# Excavation Scope Final Design

Arup Final Design Kick-Off Meeting

November 7, 2017

# Changes from what you've seen in the PDR

## Proximity Cryogenics in Detector's Cavern – Mezzanine 2/2

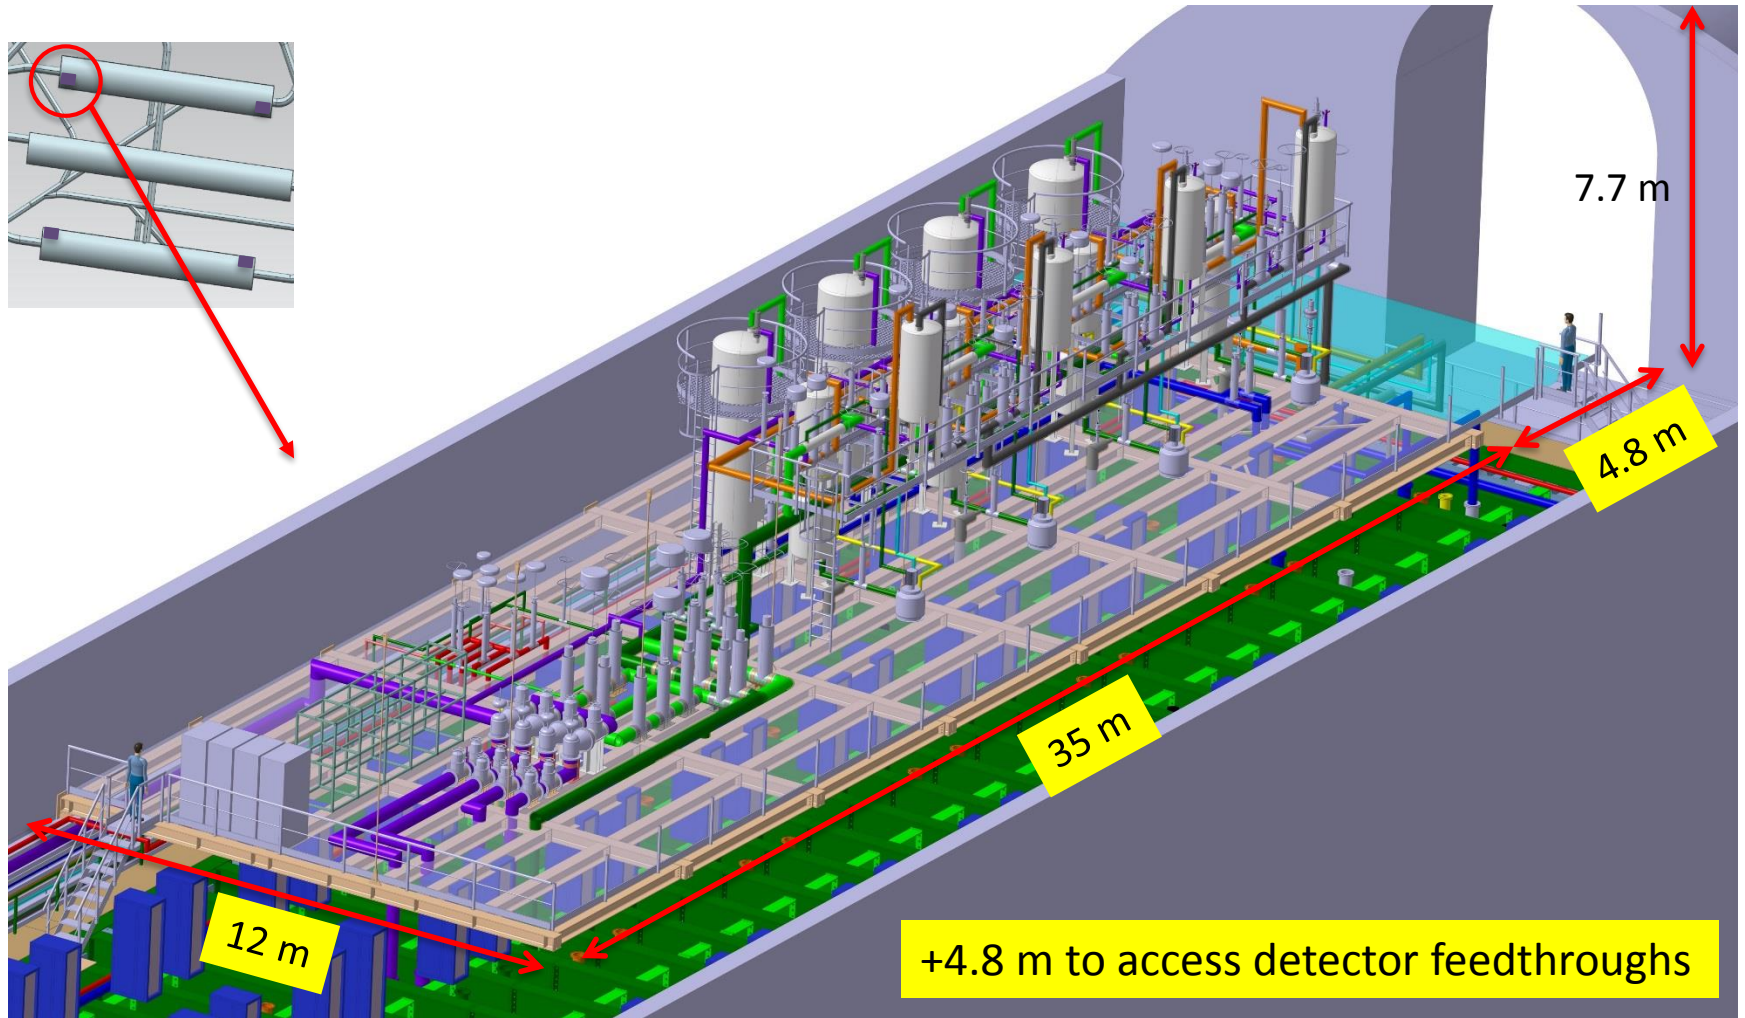
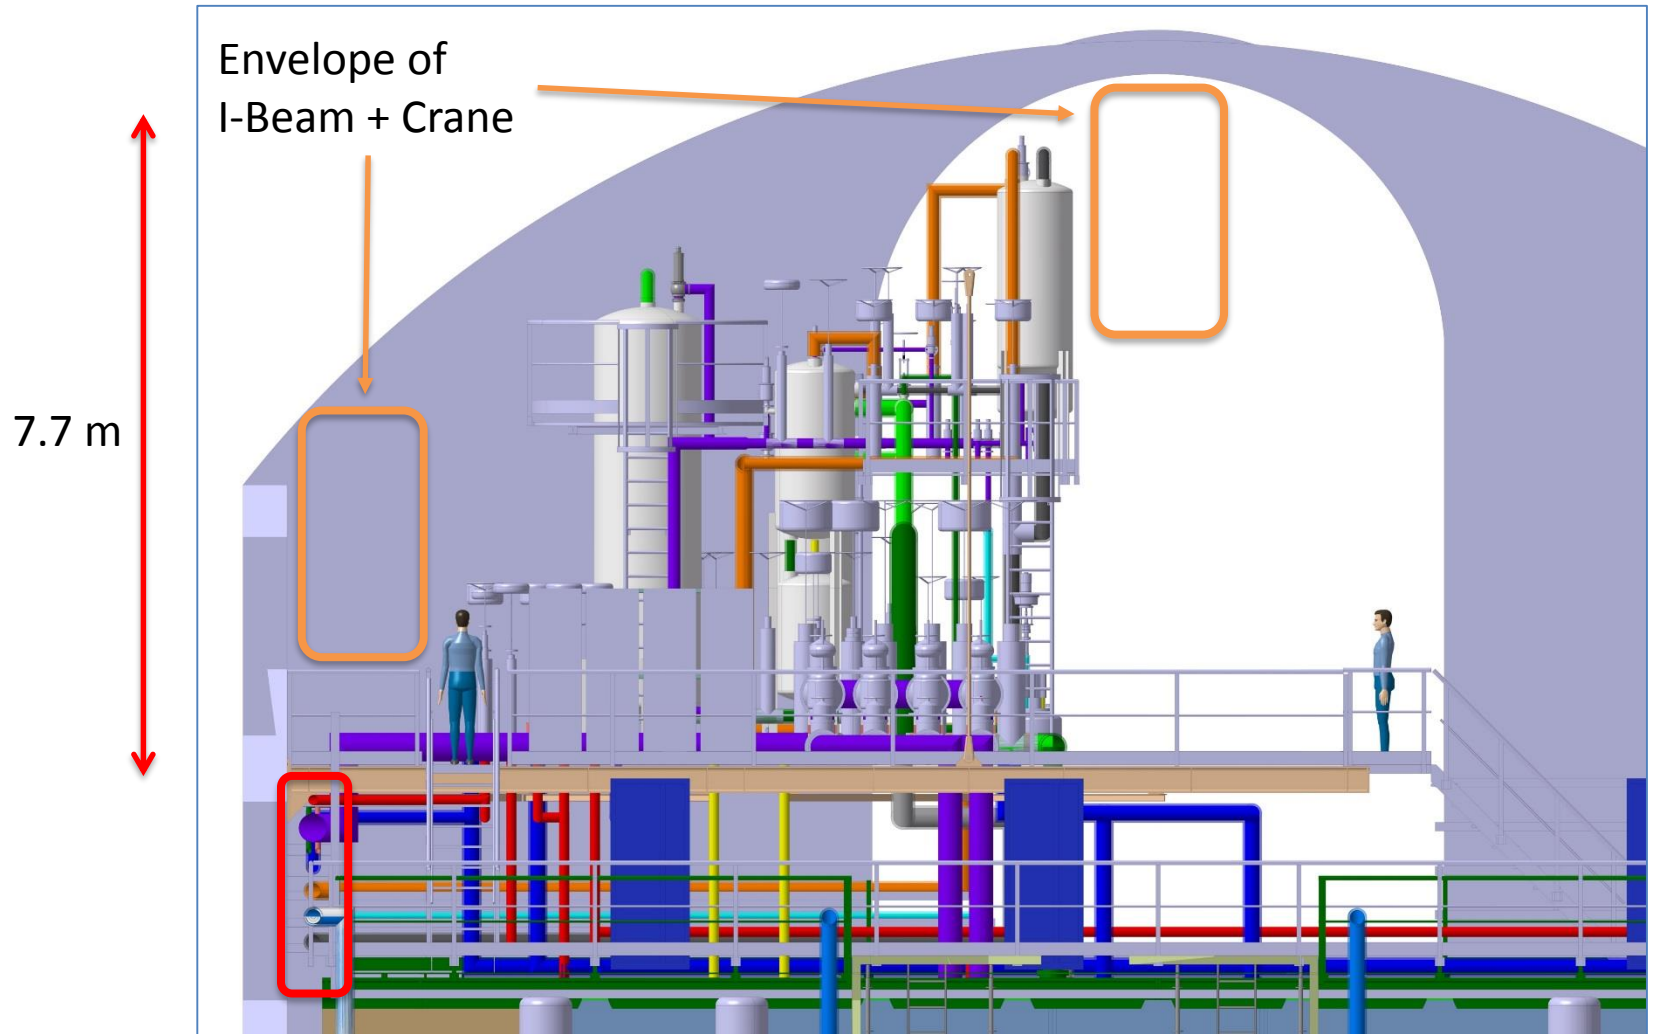
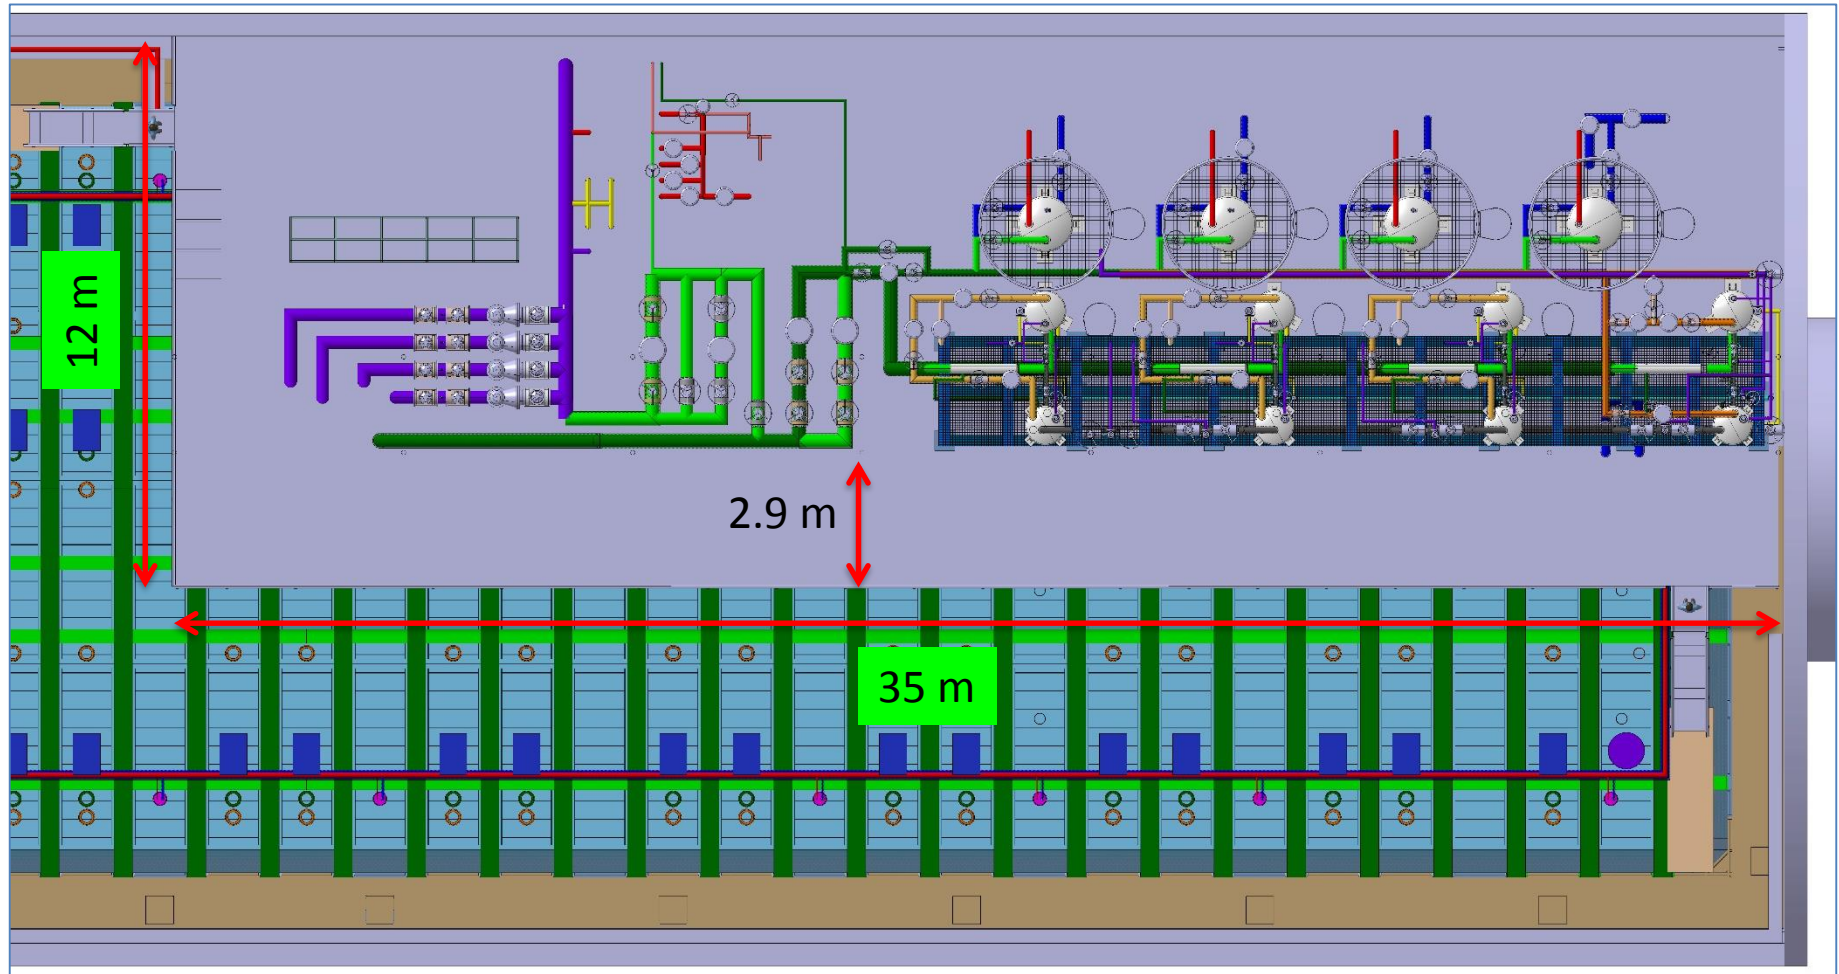
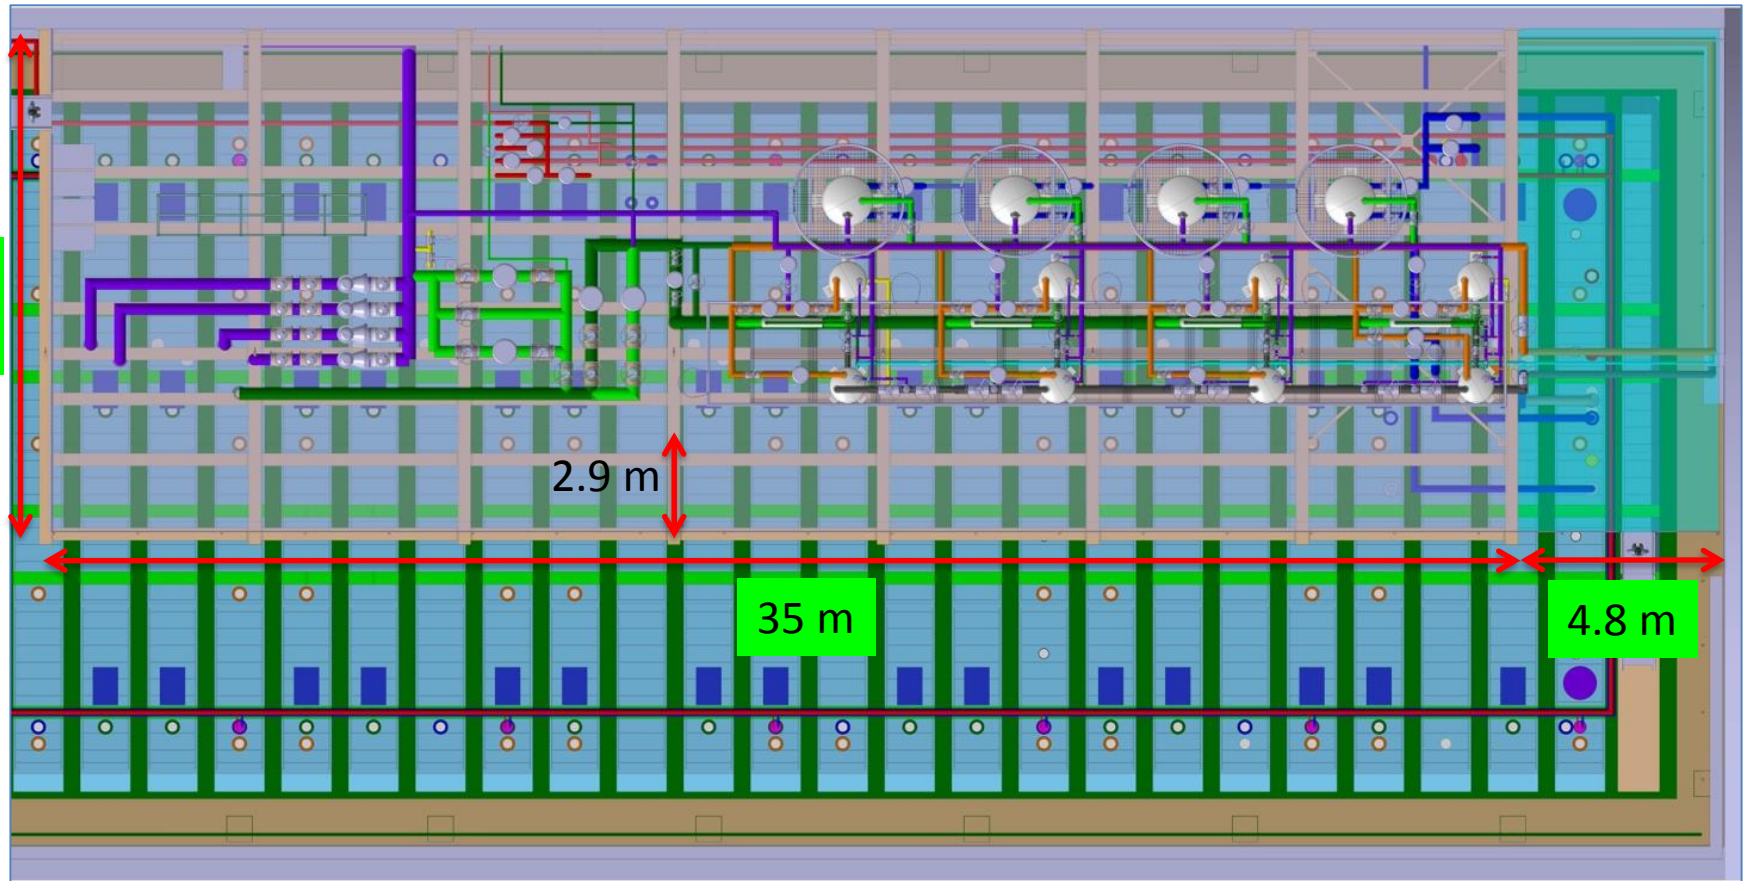
- Updates from previous meeting:
  - Mezzanine platform shifted 4.8 m towards the center of the cryostat for detector access (vertical space available for feedthroughs insertion).
  - Design being updated to reflect updated cryostat feedthroughs layout.
- Design almost identical for Single Phase and Dual Phase. Dual Phase requires a few modifications because of the operating pressure range.

+4.8 m to access detector feedthroughs
